34-38 Southampton Street, Reading

NMA application - supporting document

April 2022
RevA - drawing list updated
RevB - elevation detail drawings added

Proposed Basement and Ground Floor Plan

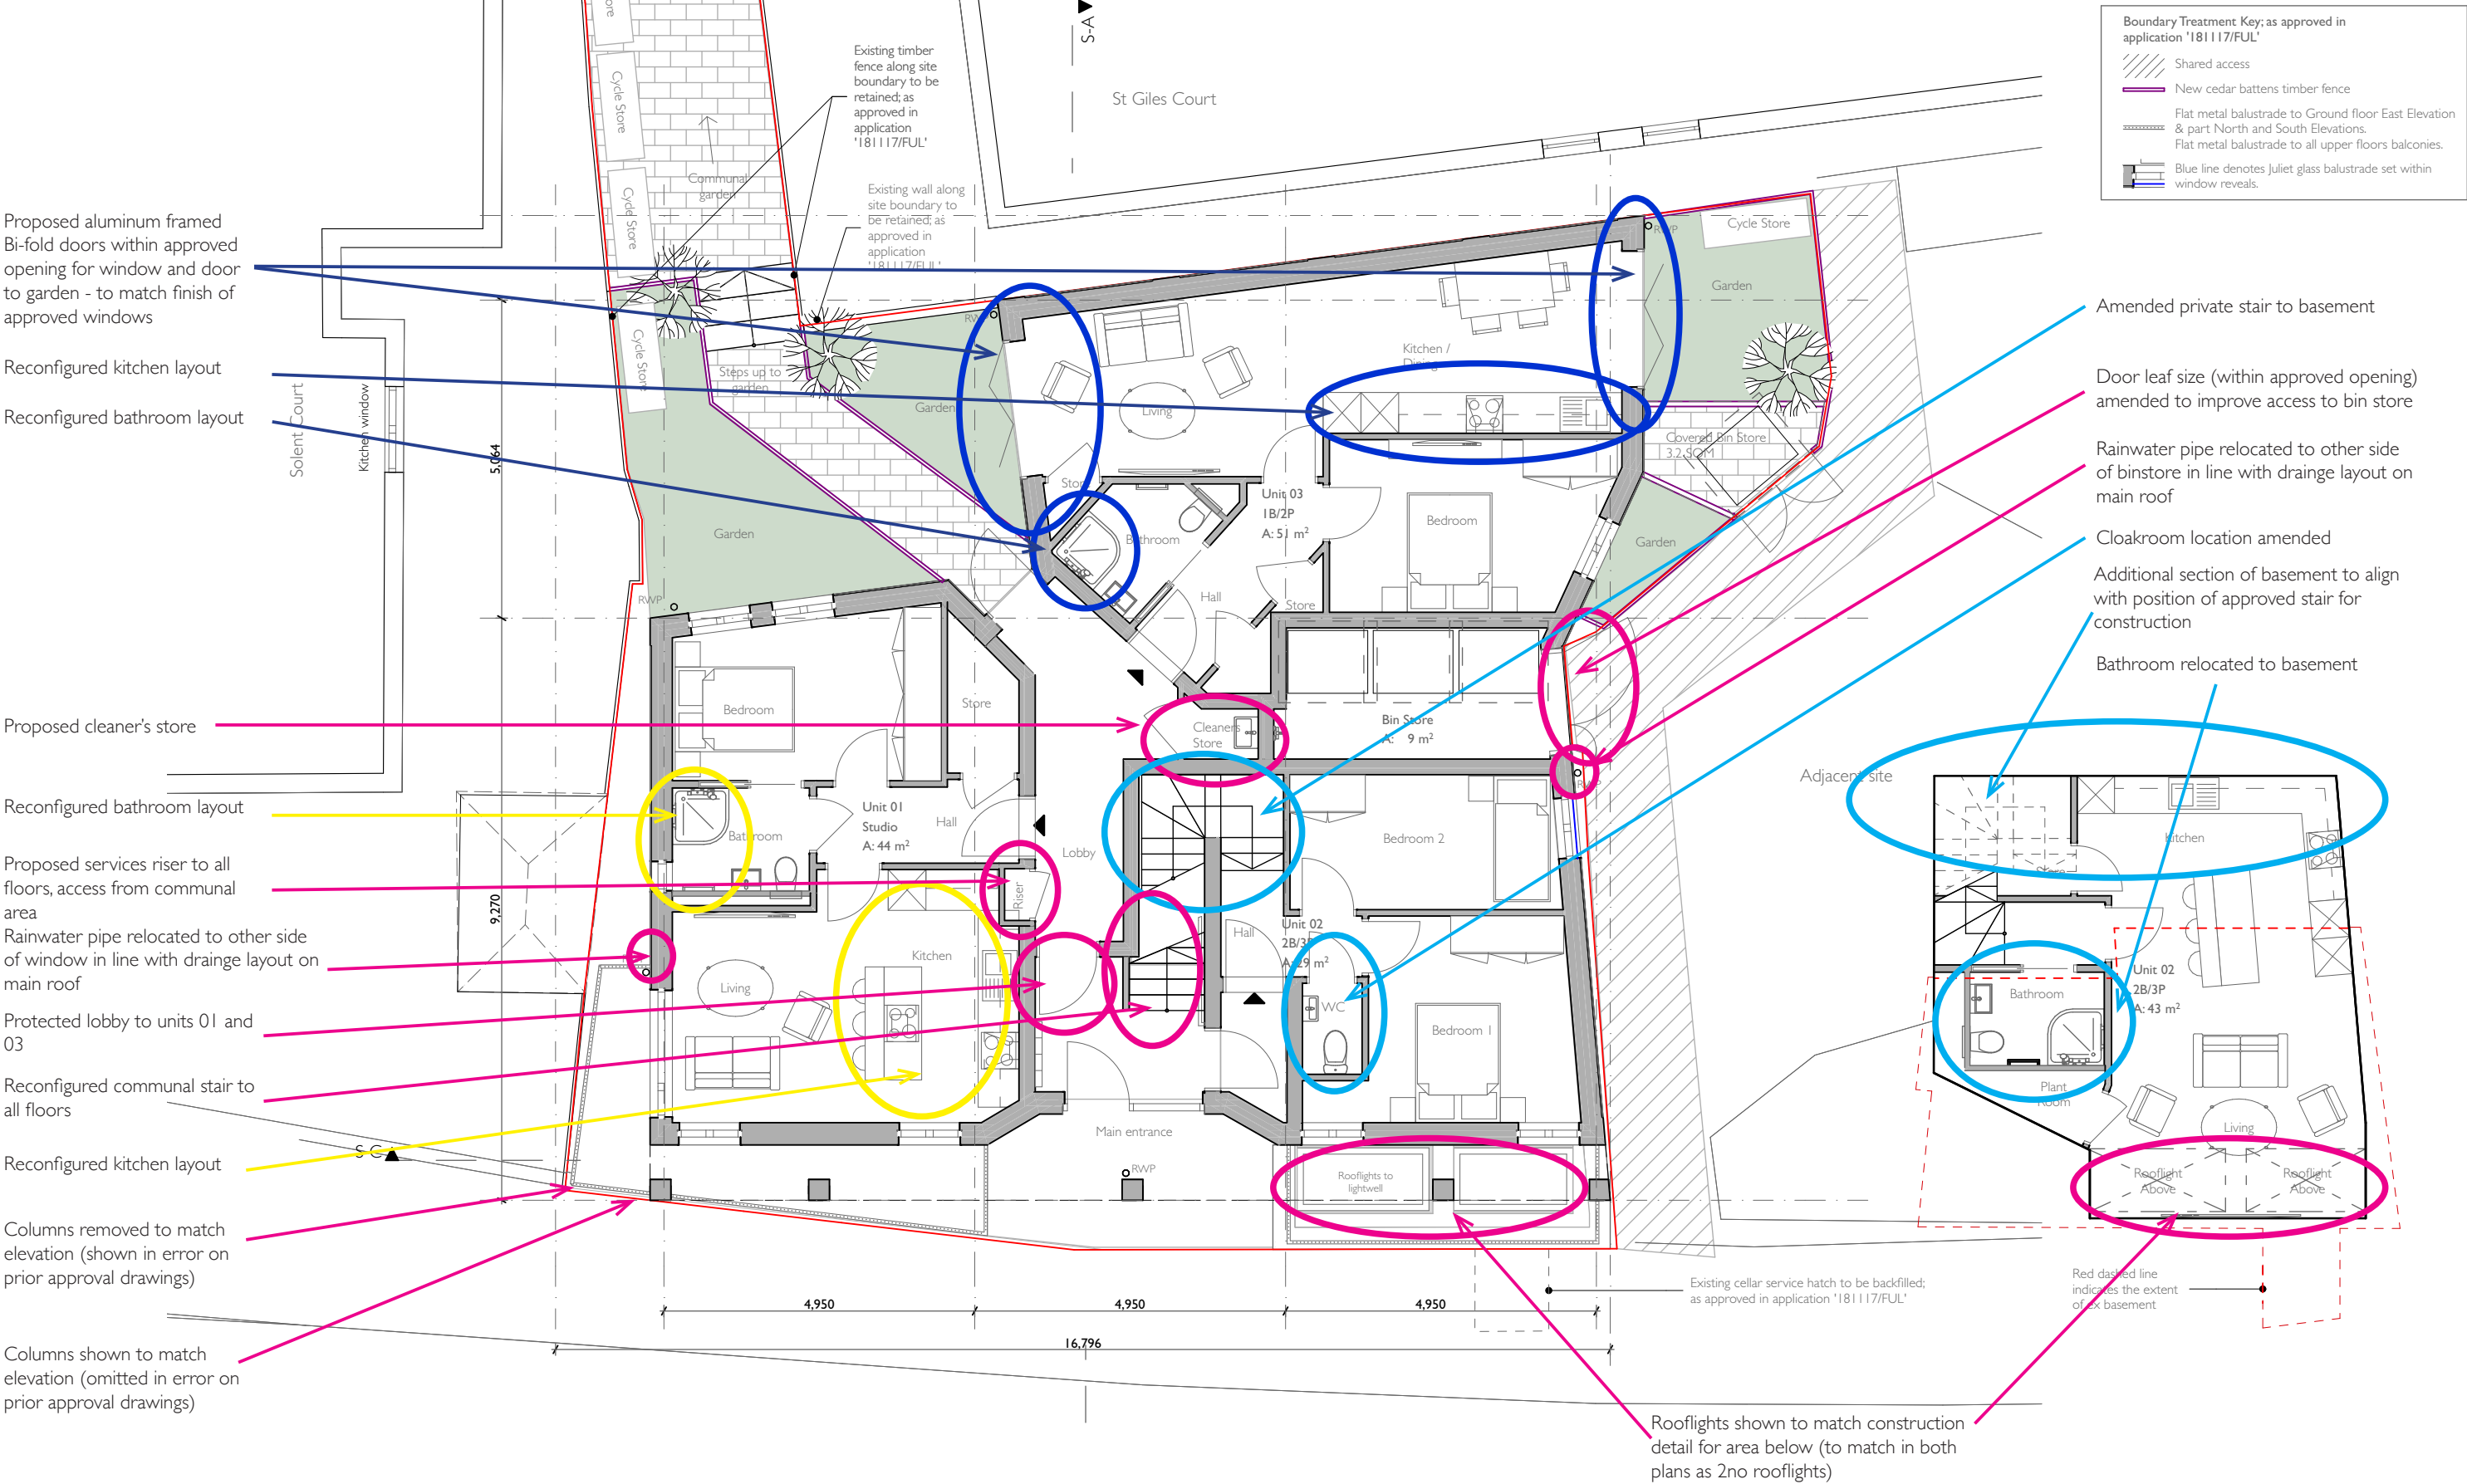
The approved basement extents did not show the construction required for excavating the stair in its approved location. The new proposal retains the position of the stair, with some minor adjustments to align with building control requirements for head-clearances. The extent of the basement has been increased slightly to encompass the stair in this location, in line with the proposed construction excavation in this area. The impacts have been assessed by archeological consultants (refer to Planning cover letter), and the alterations are not visible due to below ground construction.

At ground floor, we are showing columns along the entrance wall in line with the approved planning elevations - there was an error in the previously approved drawings which did not show these on plan. Similarly, the rooflights to the basement appear slightly reduced in size to accurately reflect construction methods required in this area.

Proposed Roof Plan

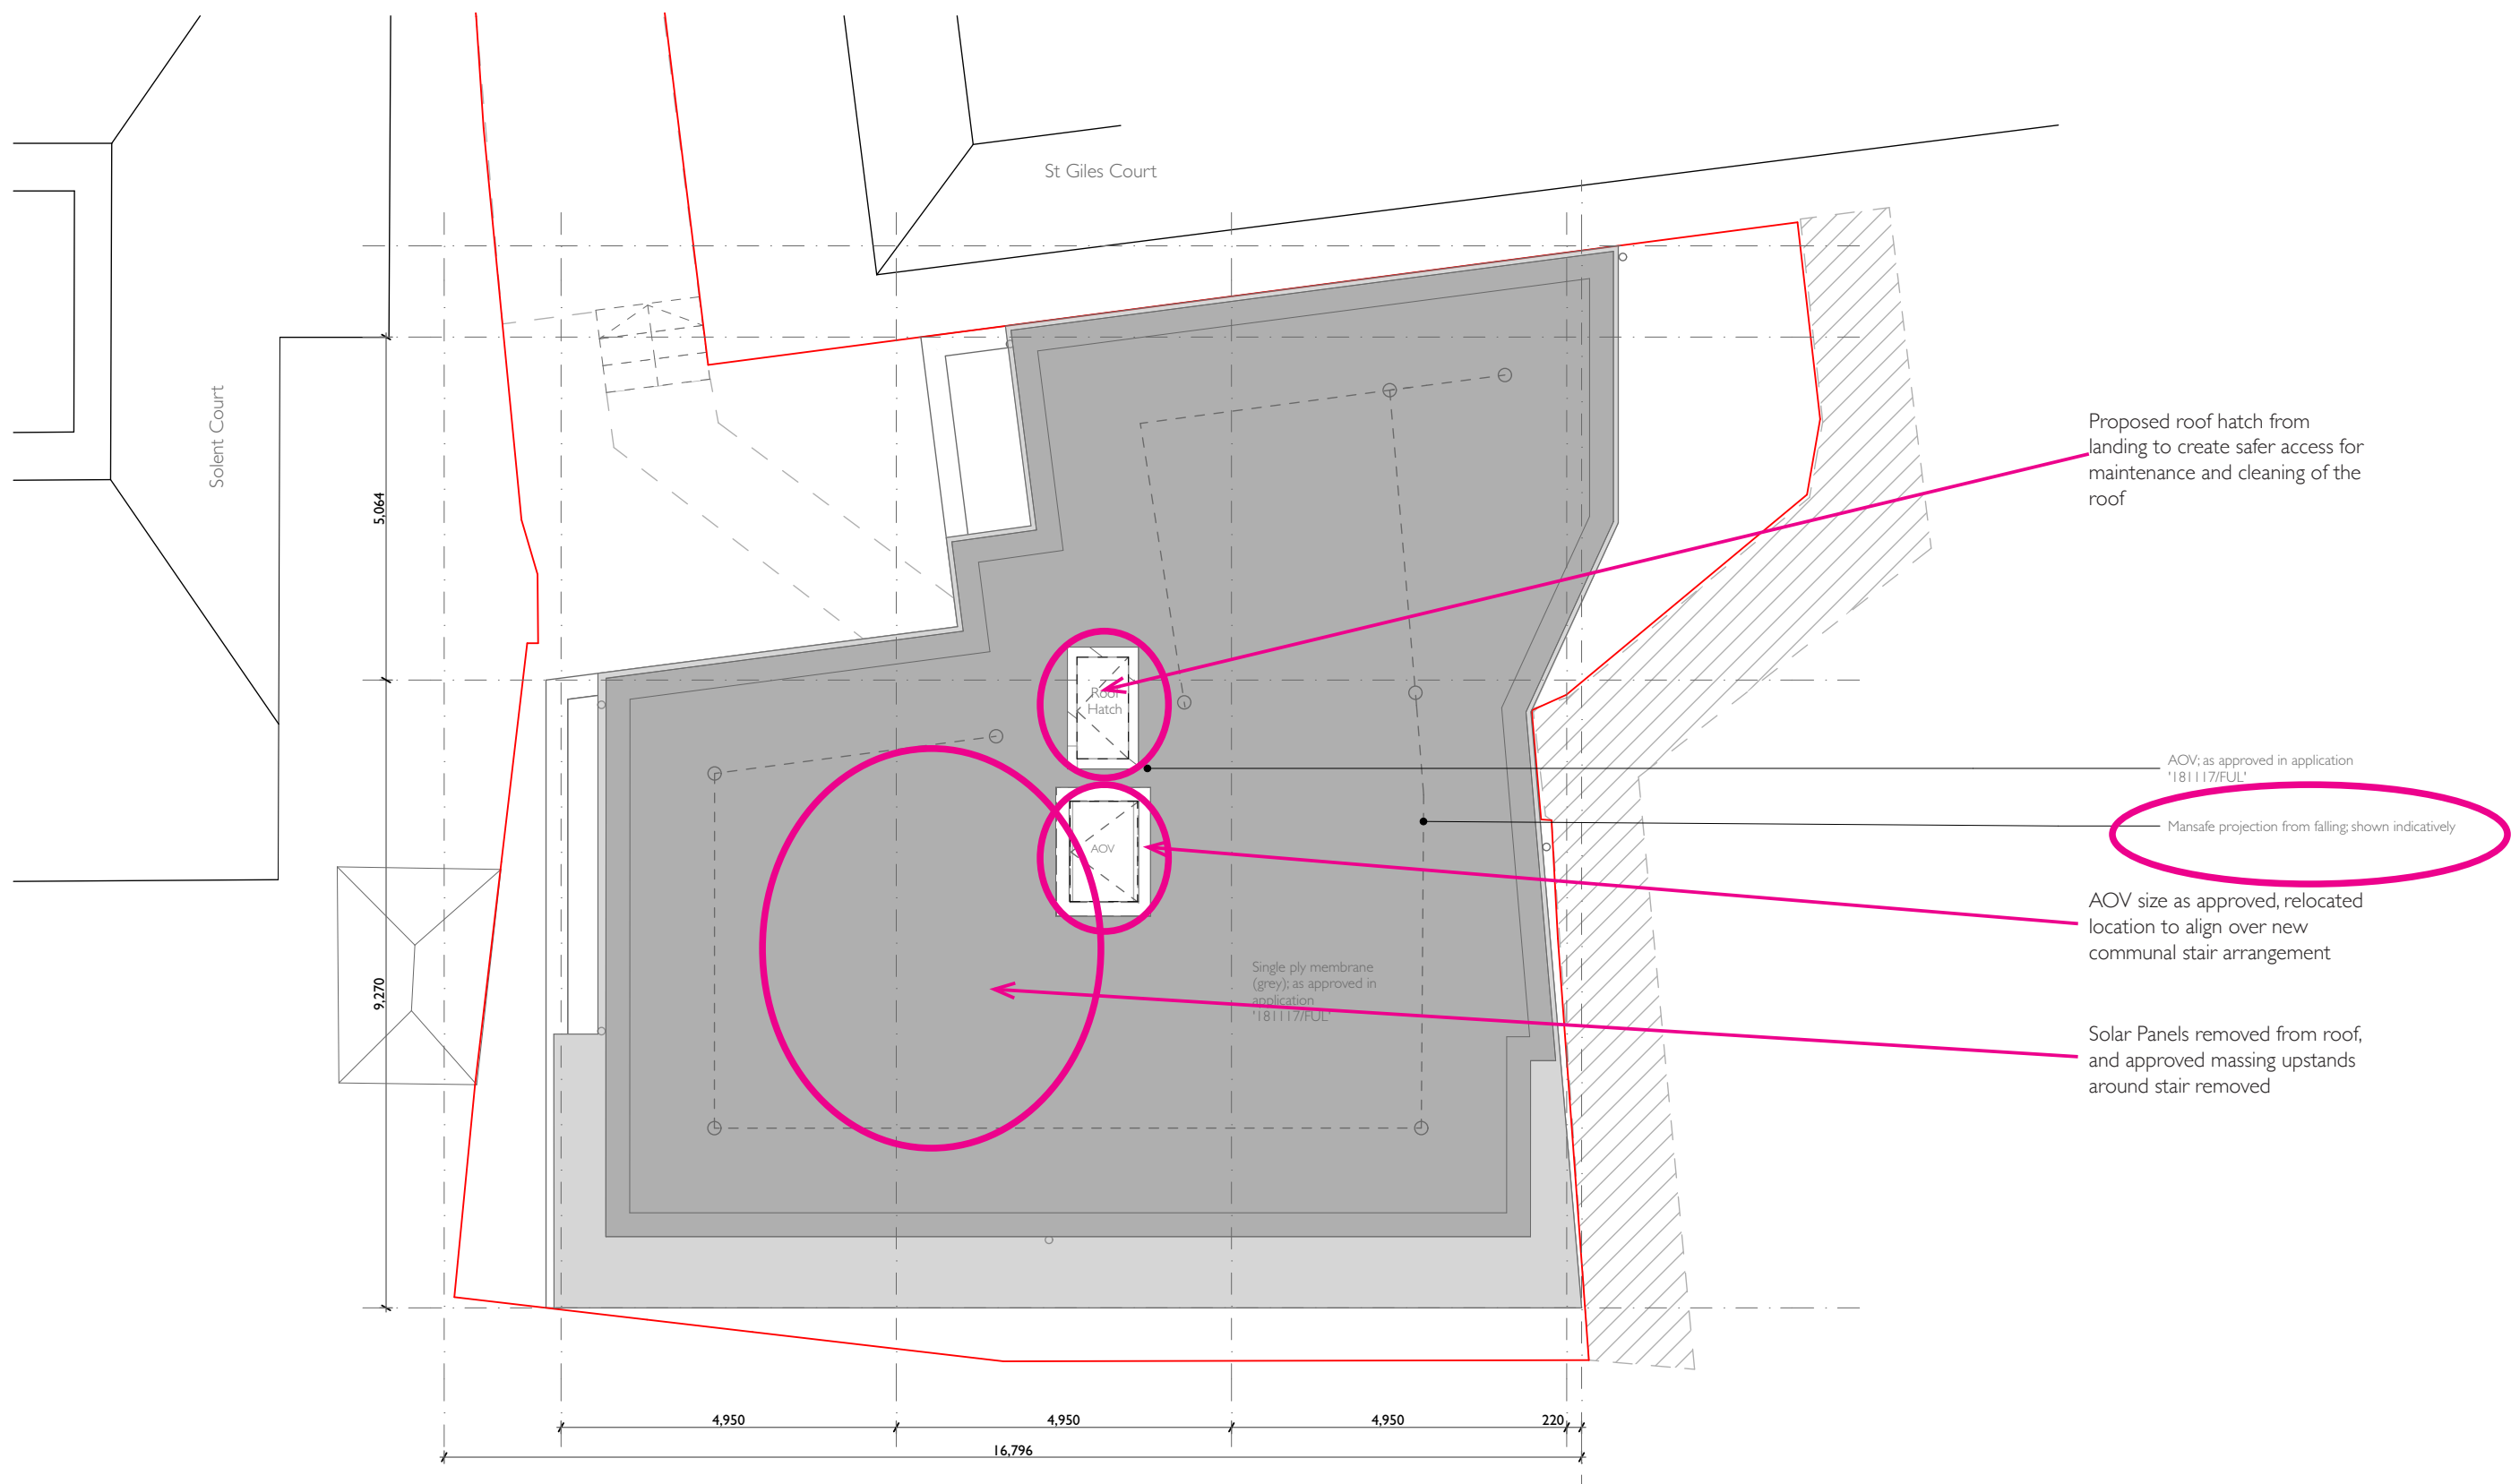
In reviewing the mechanical design for the performance of the building, alongside the building fabric, we were able to remove the solar panels from the roof, to facilitate a neatening of the visible elements and reduce the overall massing. Accurate construction detailing has informed a slight increased thickness of the external walls, which is taken internally with no impact on the external footprint of the building - the dimensioned setting out of the proposal is shown on all drawings, which aligns to the approved scheme exactly.

South Elevation

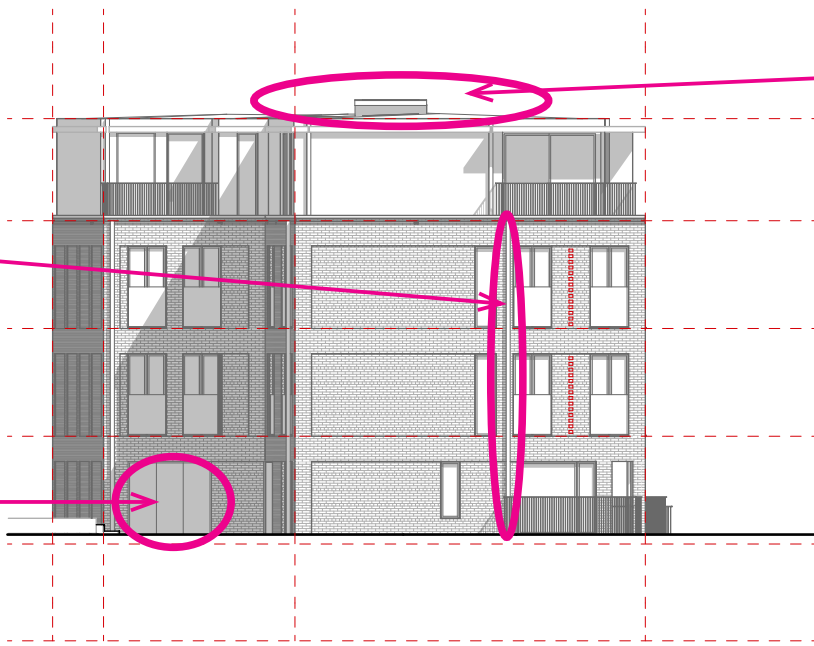
Rainwater pipe relocated to other side of window in line with drainage layout on main roof

Proposed aluminum framed Bi-fold doors within approved opening for window and door to garden - to match finish of approved windows

Solar Panels removed from roof, and approved massing upstands around stair removed

North Elevation

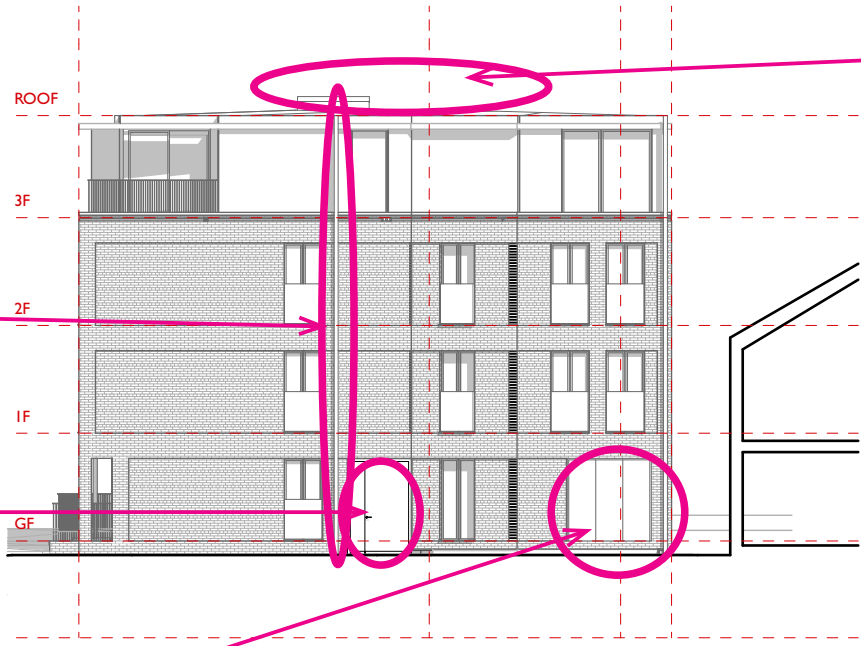
Rainwater pipe relocated to other side of binstore in line with drainage layout on main roof

Bin store door leaf arrangement altered within approved opening for improved access

Proposed aluminium framed Bi-fold doors within approved opening for window and door to garden - to match finish of approved windows

Solar Panels removed from roof, and approved massing upstands around stair removed
